4-4-88

I wish to appeal the Building Departments decision concerning the legality of the zoning of a proposed driveway located between 51 Dana Street and 407A and 409 Broadway. Enclosed please find a copy of the applicable zoning regulation and a plan of the proposed site.

Comm. from Margot Silin to Inspectional Services Commissioner Joseph Cellucci regarding the petition of Ruth Hiller for a driveway at 409 Broadway.

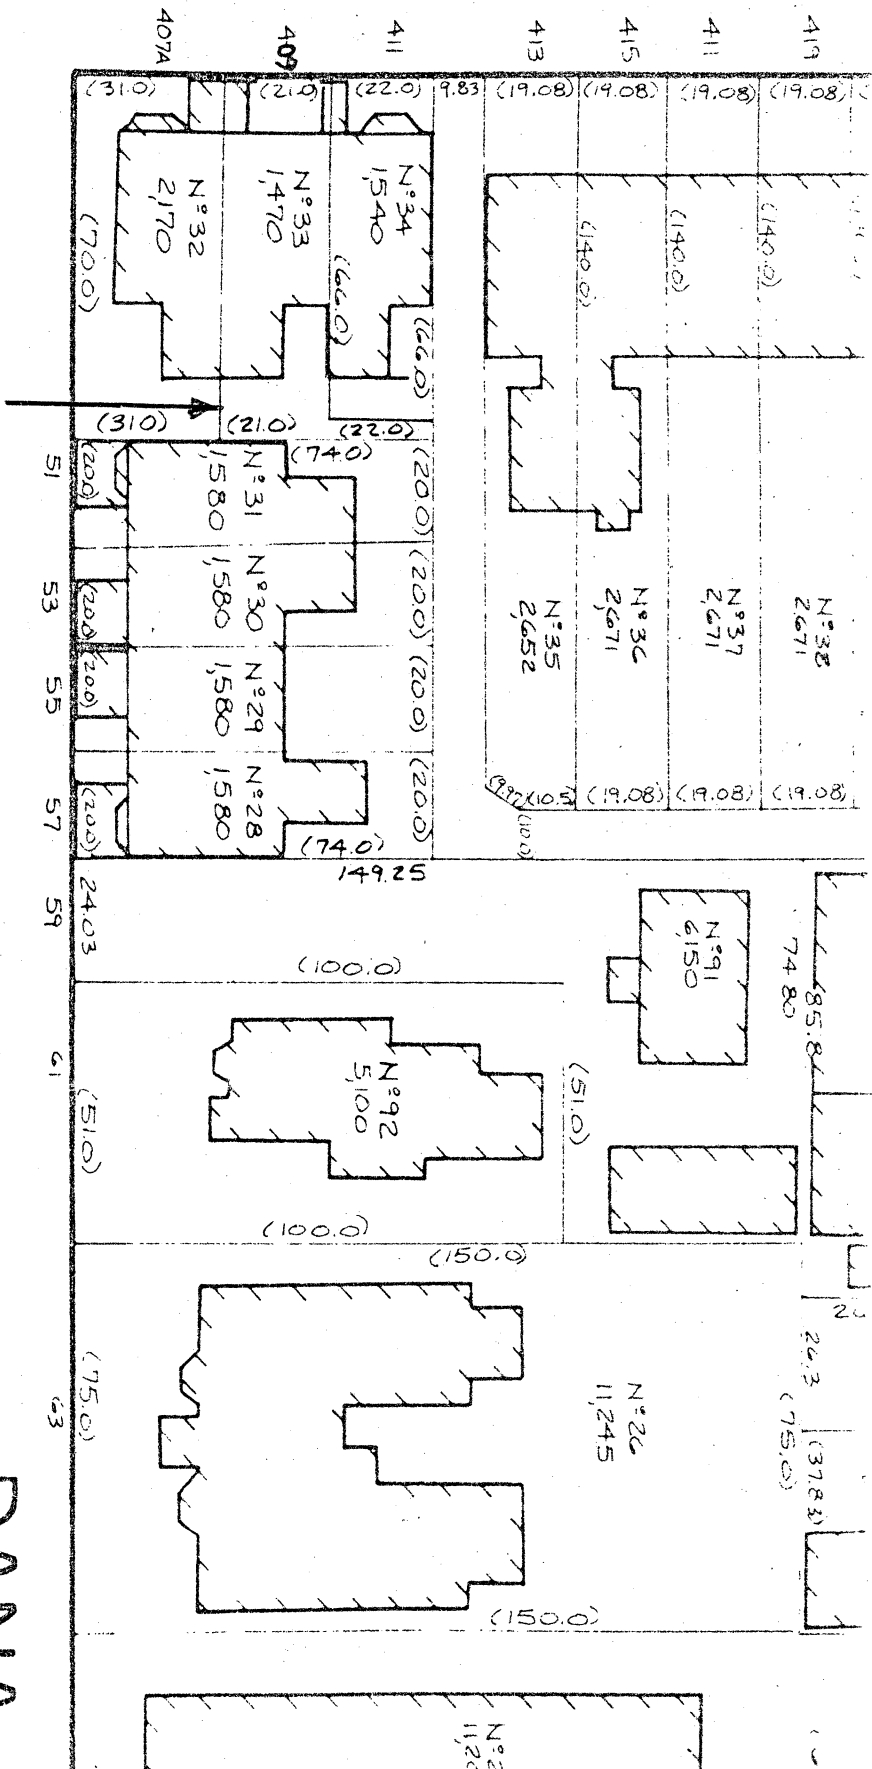
The measured distance between the wall at the rear of 407A and 409 Broadway and the side wall of 51 Dana St. is only 10 feet. The 407A and 409 Broadway wall has windows on all floors including the basement, while the 51 Dana St. wall has windows on the second and third floors.

407A Broadway is a four unit building while 51 Dana St. is a three unit building. According to Article 6.441 Part (a) of the Zoning Code a setback of ten feet is required from a four unit building. Consequently, I don't see how a driveway at this location is possible.

There may be some question as to whether the occupancy of 407A Broadway is legal as a four family (even though it is so listed with Rent Control). If in fact it can only be considered as a three family (which 409 Broadway probably is) the setback requirement according to Article 6.441 is five feet.
